Access Compliance Report

Public Rights-of-Way

(Island Curb Cuts)

| Intersection ID: 11457 | Main Street: TRYON-CHURCH_CONNECTOR_ST | Cross Street: N_CHURCH_ST | Location: E |

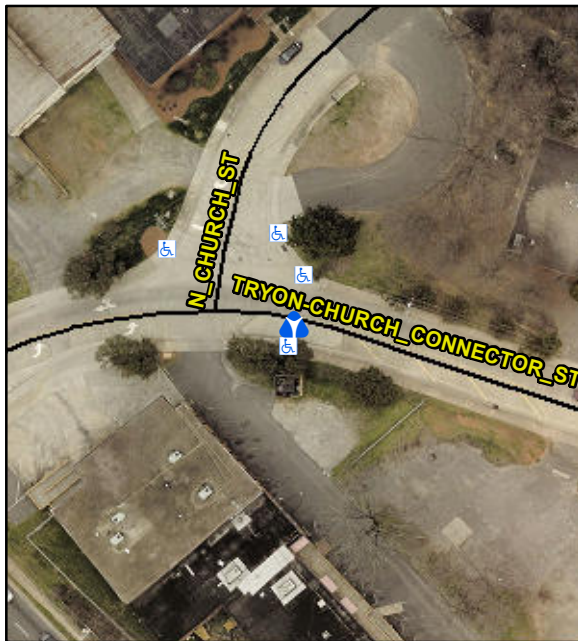
| ADA ID: B3DA1F7FA0FC | Curb Cut Type: MedianRefuge2 | Initial Pass/Fail: Fail | Overall Compliance: No |

| Compliance | Description | Data | Compliance | Description | Data |
|------------|----------------------|------|------------|-----------------------------|------|
| No | Refuge 1 Slope (%) | 6.3 | N/A | Gutter 1 Slope (%) | N/A |
| No | Refuge 2 Slope (%) | 7.2 | N/A | Gutter 2 Slope (%) | N/A |

Remove & Replace Entire Refuge.
